**SECTION 00 90 01
BIDDING AND CONTRACT REQUIREMENTS
ADDENDUM NUMBER (5)**

Issued: April 30th, 2024

Re: ADDENDUM NUMBER (5) TO THE BIDDING DOCUMENTS FOR

**Peoria Park District
Golf Entertainment Facility Renovation an Addition
Architect's Project Number: 22-051**

SHEET TITLE:
FIRST FLOOR PLAN - CLUBHOUSE - NEW SYSTEMS

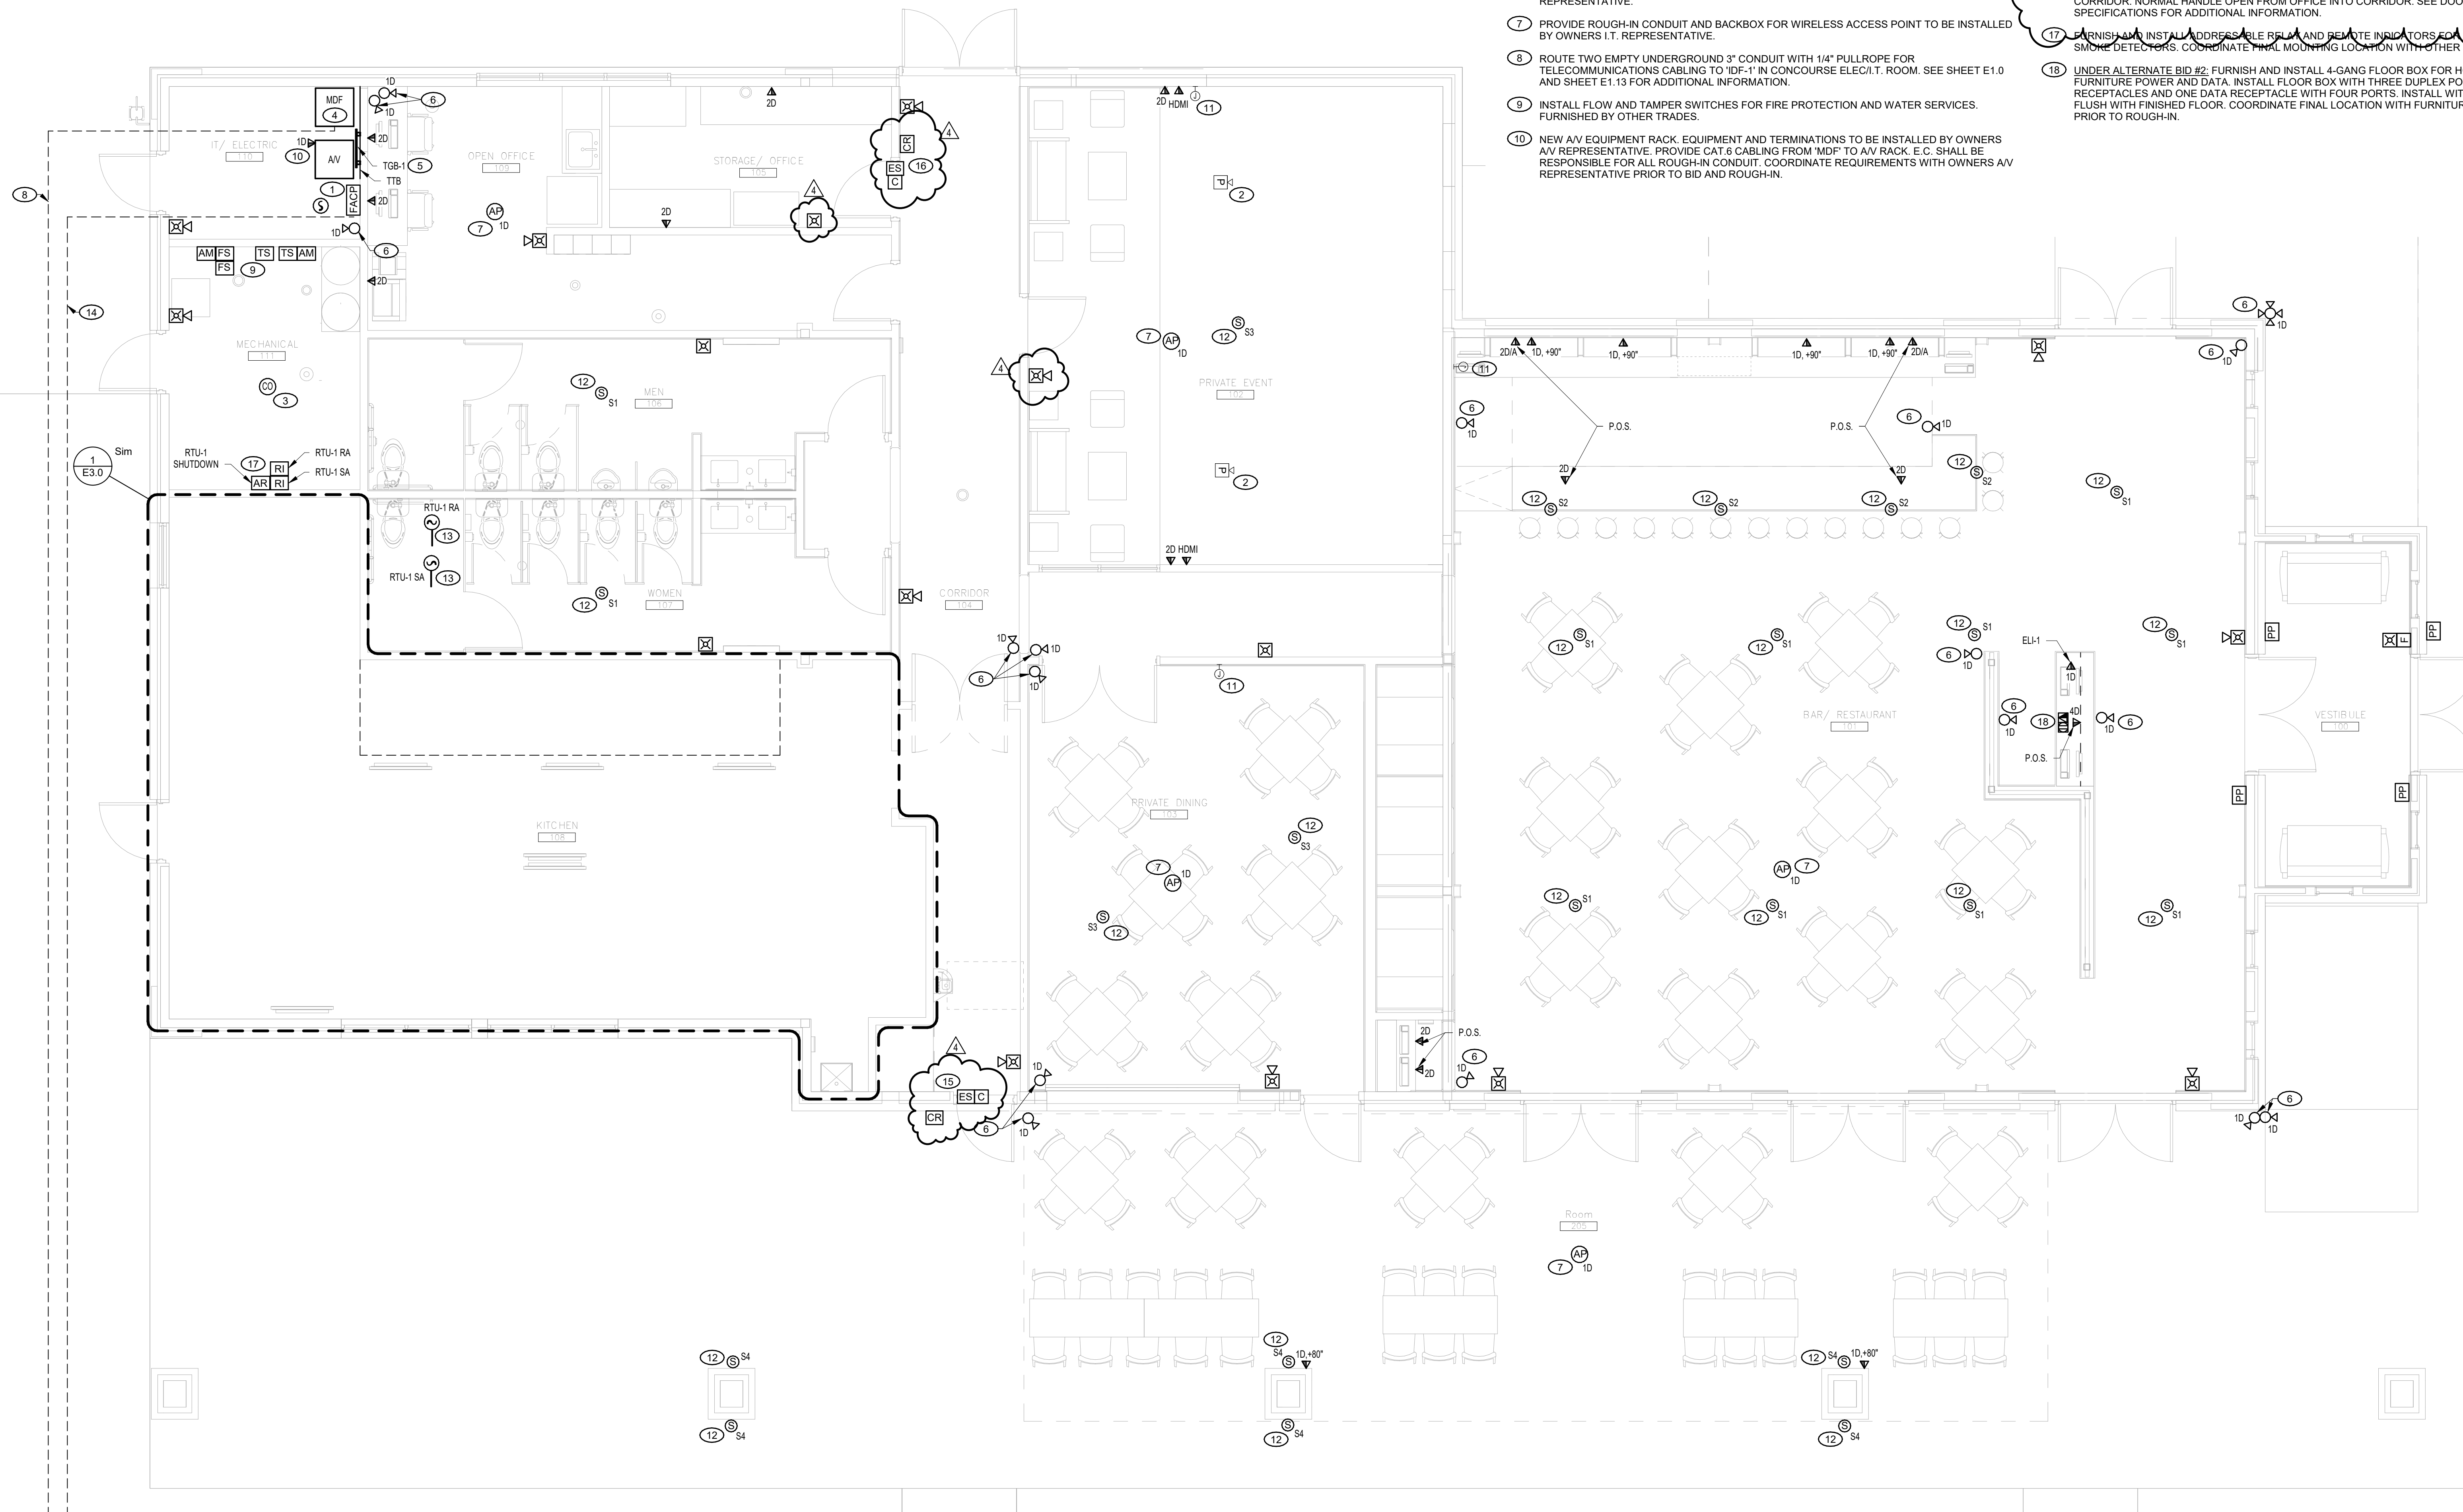
1. Drawing E1.03 – FIRST FLOOR PLAN – CLUBHOUSE – NEW SYSTEMS
 - b. Revise audio/visual fire alarm device location from middle of corridor 104 into Private Event 102.

- c. Add visual only notification device in Storage/Office 105.
 - d. Revised drawings to remove access controls from door 104A and door 109A.
 - e. Added access controls for doors 105A and 108B.

- f. Revise keyed note #15 clarifying door access control requirements for door 108B.
 - g. Revise keyed note #16 clarifying door access control requirements for door 105A.

2. Drawing E1.03 – FIRST FLOOR PLAN – CLUBHOUSE – NEW SYSTEMS
- a. Revise audio/visual fire alarm device location from middle of corridor 104 into Private Event 102.

- b. Add visual only notification device in Storage/Office 105.
 - c. Revised drawings to remove access controls from door 104A and door 109A.
 - d. Added access controls for doors 105A and 108B.

- e. Revise keyed note #15 clarifying door access control requirements for door 108B.
 - f. Revise keyed note #16 clarifying door access control requirements for door 105A.

- 14 ROUTE ONE EMPTY UNDERGROUND 3" CONDUIT WITH 1/4" PULLROPE FOR FIRE ALARM NOTIFICATION. SEE SHEET E1.02 FOR ADDITIONAL INFORMATION.
- 15 ACCESS CONTROLLED STAFF ENTRY DOOR. CARD/FOB READER INTO BUILDING FROM EXTERIOR. CRASH BAR EGRESS TO EXTERIOR FROM CORRIDOR. ELECTRIC STRIKE RELEASE. SEE DOOR HARDWARE SPECIFICATIONS FOR ADDITIONAL INFORMATION.

SHEET NUMBER:
E1.12

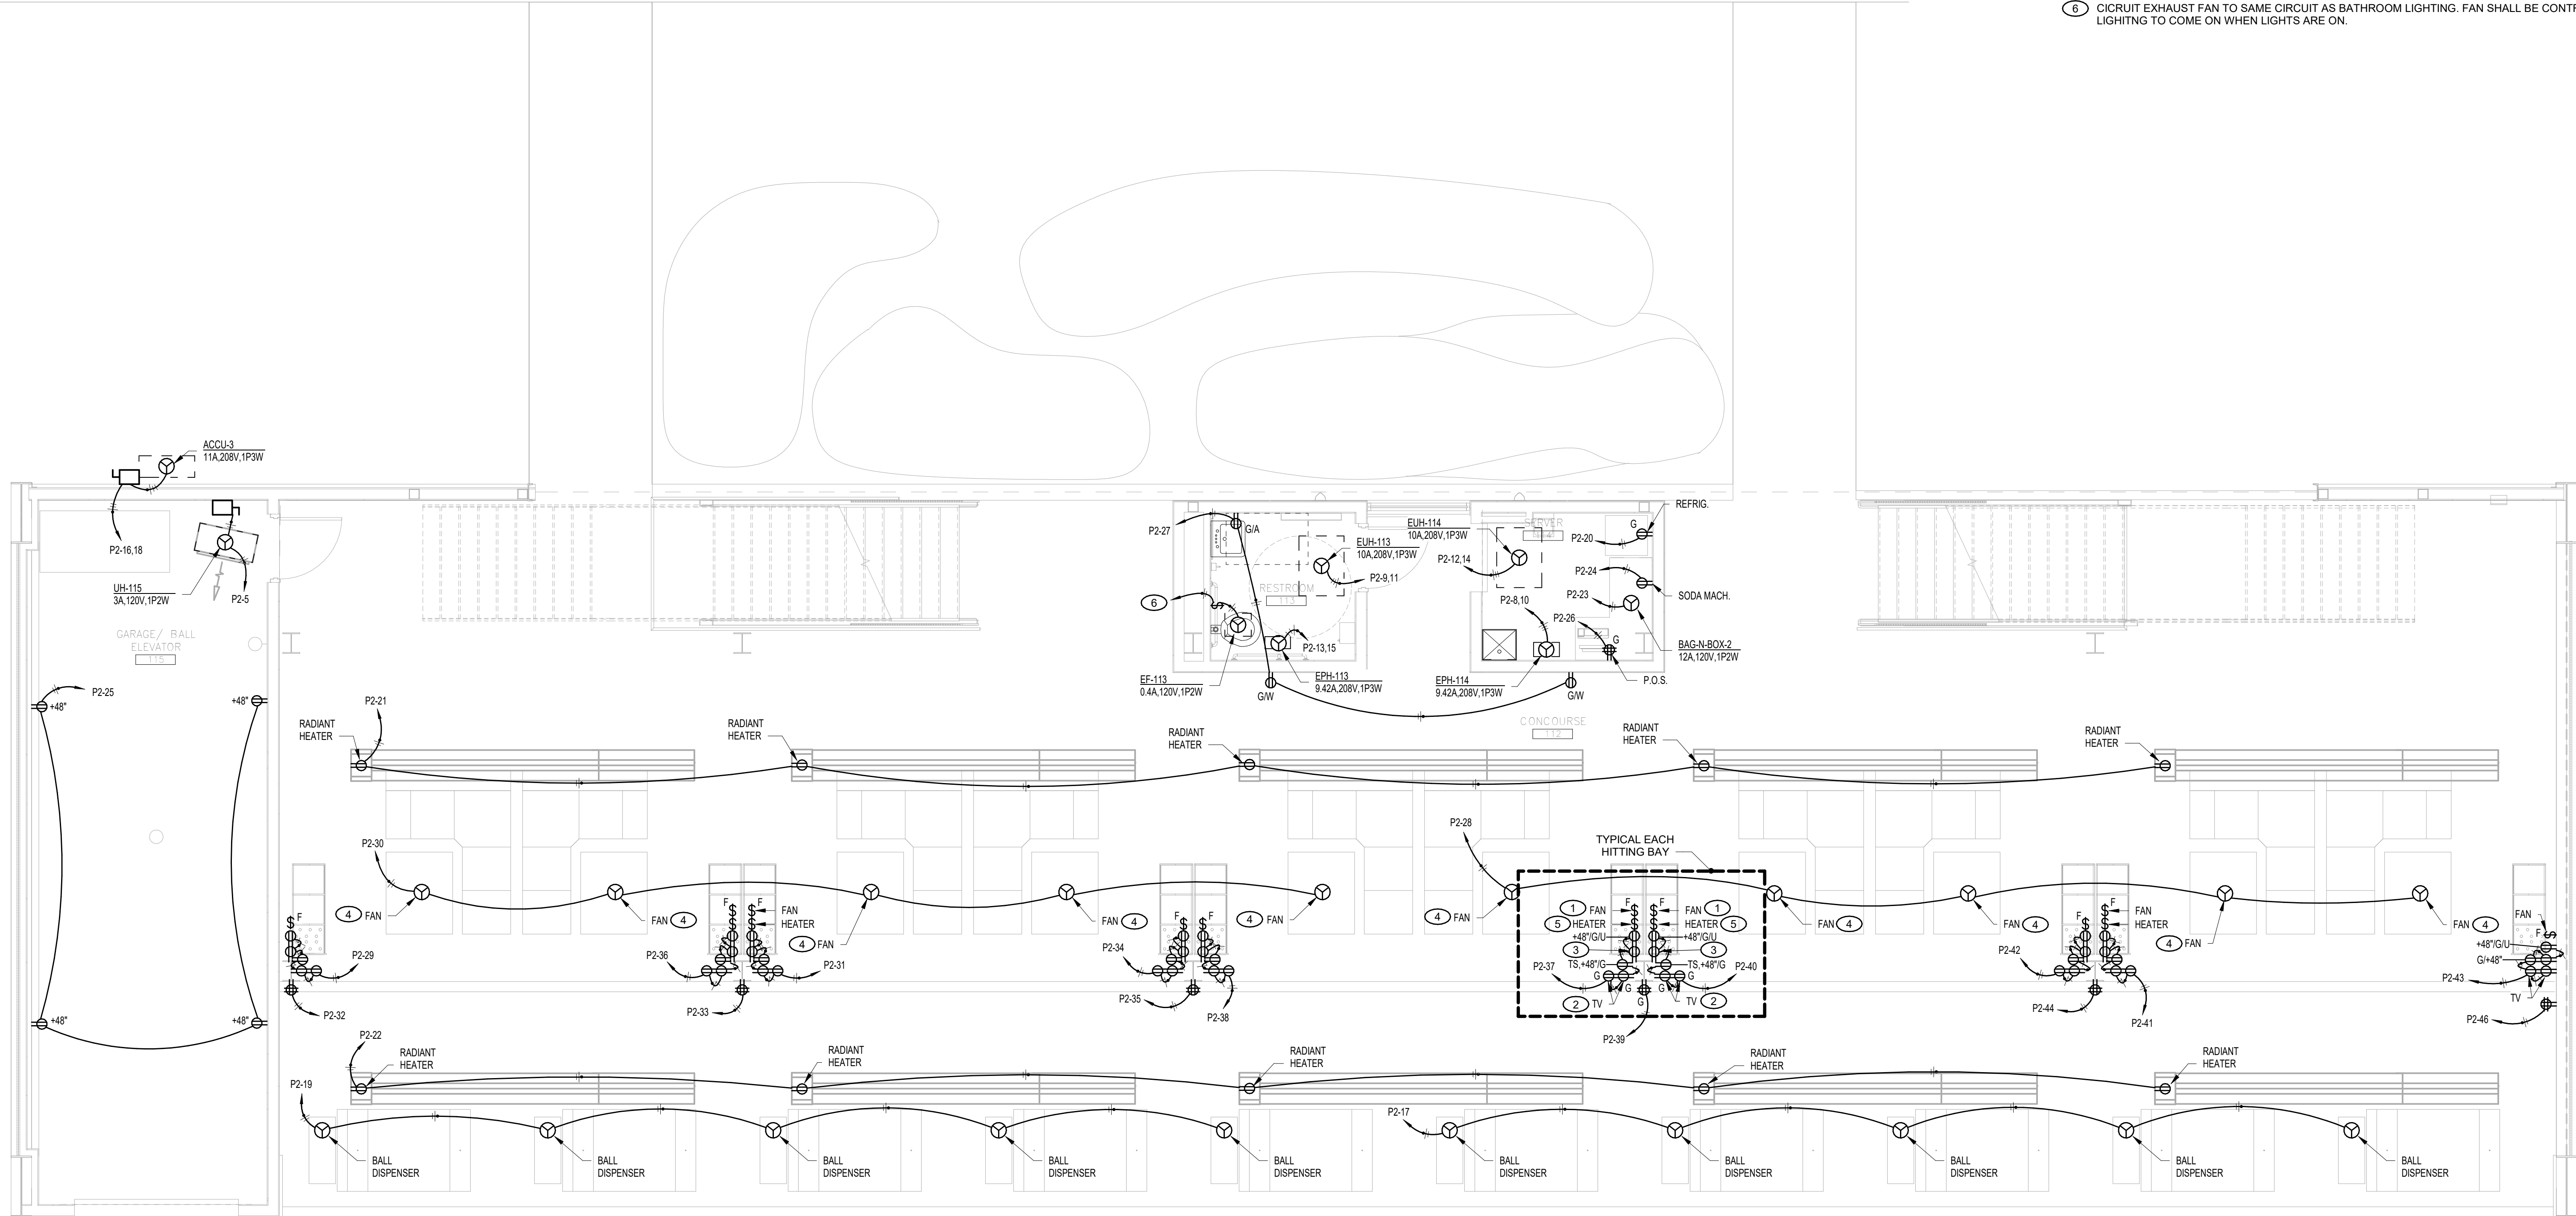
4. Drawing E1.12 – FIRST FLOOR PLAN – RANGE BAYS – POWER
 - a. Revise keyed note #4 to have E.C. furnish and install ceiling fans in hitting bays. Final selections shall be coordinated and approved by the architect prior to release.

3. Drawing E1.12 – FIRST FLOOR PLAN – RANGE BAYS – POWER
- a. Revise keyed note #4 to have E.C. furnish and install ceiling fans in hitting bays. Final selections shall be coordinated and approved by the architect prior to release.

- 4 FURNISH AND INSTALL CEILING FAN AT LOCATION. COORDINATE ORDERING OF CEILING FANS WITH ARCHITECT PRIOR TO ORDERING. FINAL SELECTIONS MUST BE APPROVED BY ARCHITECT. VERIFY EXACT FAN LOCATION WITH ARCHITECTURAL BAY LAYOUT DRAWINGS AND ELEVATIONS PRIOR TO ROUGH-IN.

SHEET NUMBER:
E1.22

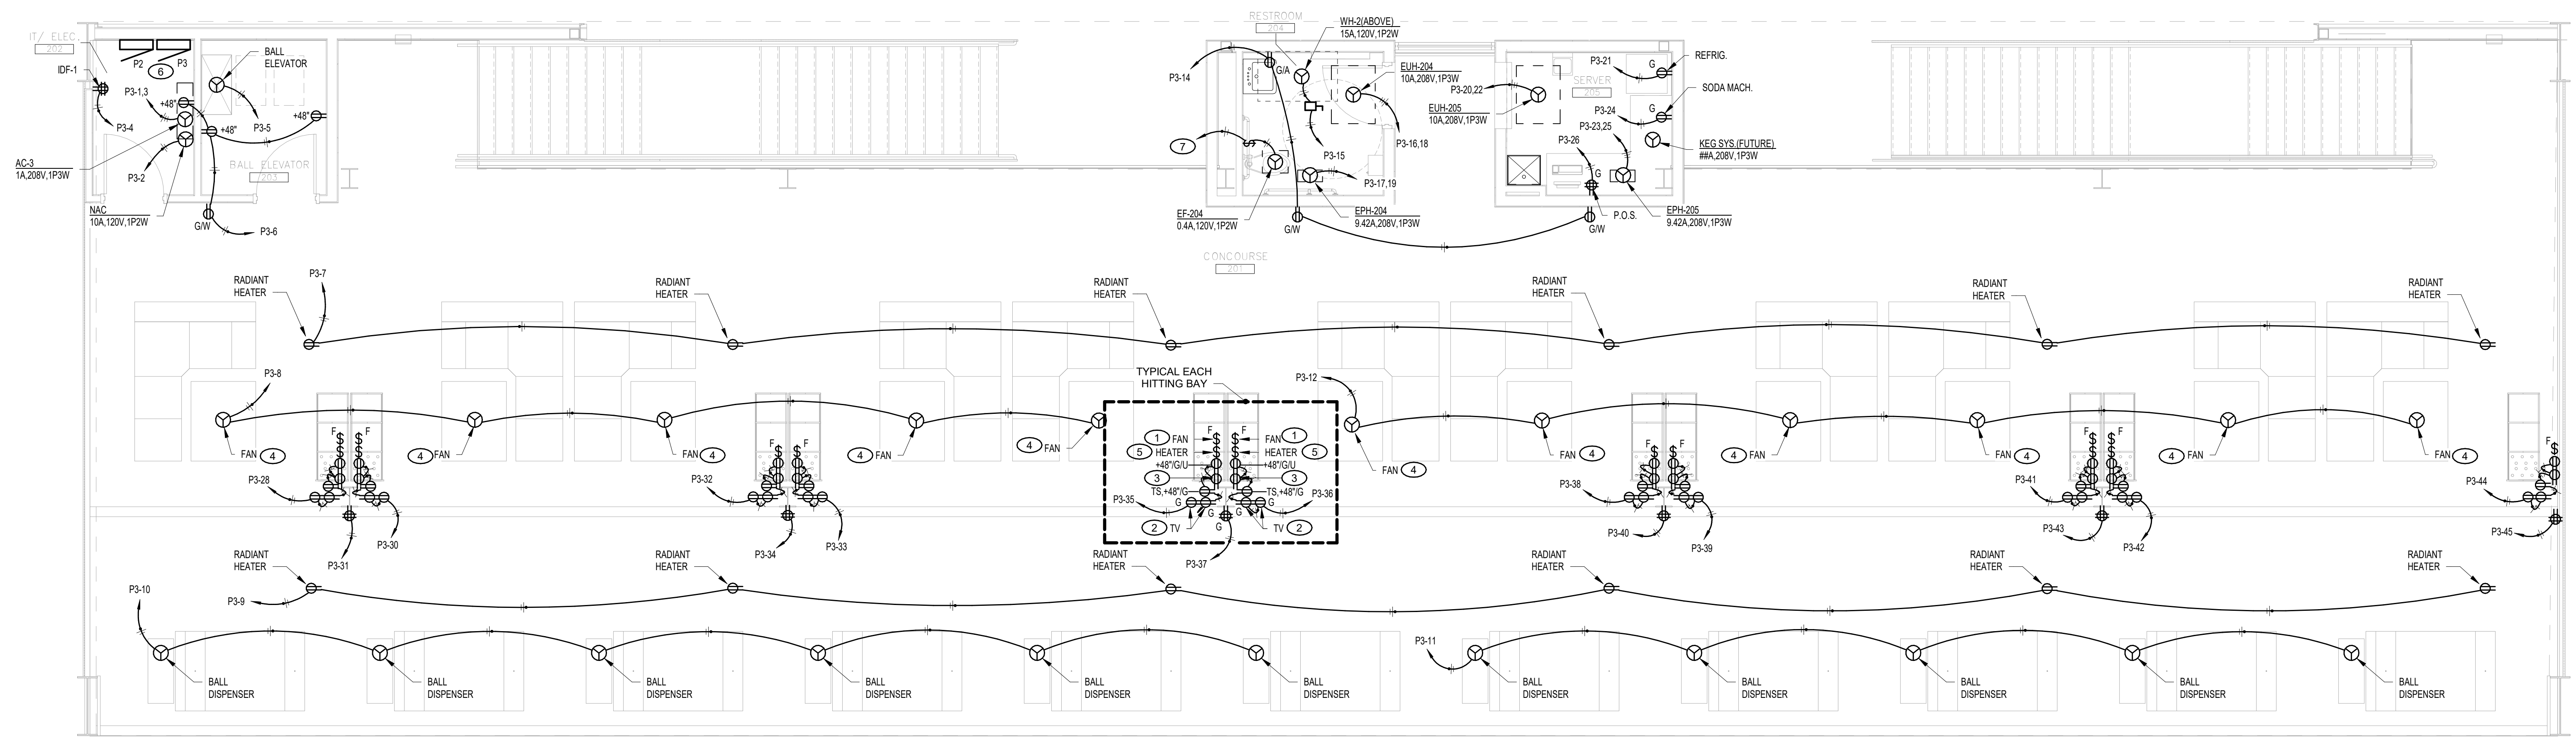
5. Drawing E1.22 – SECOND FLOOR PLAN – RANGE BAYS – POWER
 - a. Revise keyed note #4 to have E.C. furnish and install ceiling fans in hitting bays. Final selections shall be coordinated and approved by the architect prior to release.

4. Drawing E1.22 – SECOND FLOOR PLAN – RANGE BAYS – POWER
- a. Revise keyed note #4 to have E.C. furnish and install ceiling fans in hitting bays. Final selections shall be coordinated and approved by the architect prior to release.

- 4 FURNISH AND INSTALL CEILING FAN AT LOCATION. COORDINATE ORDERING OF CEILING FANS WITH ARCHITECT PRIOR TO ORDERING. FINAL SELECTIONS MUST BE APPROVED BY ARCHITECT. VERIFY EXACT FAN LOCATION WITH ARCHITECTURAL BAY LAYOUT DRAWINGS AND ELEVATIONS PRIOR TO ROUGH-IN.
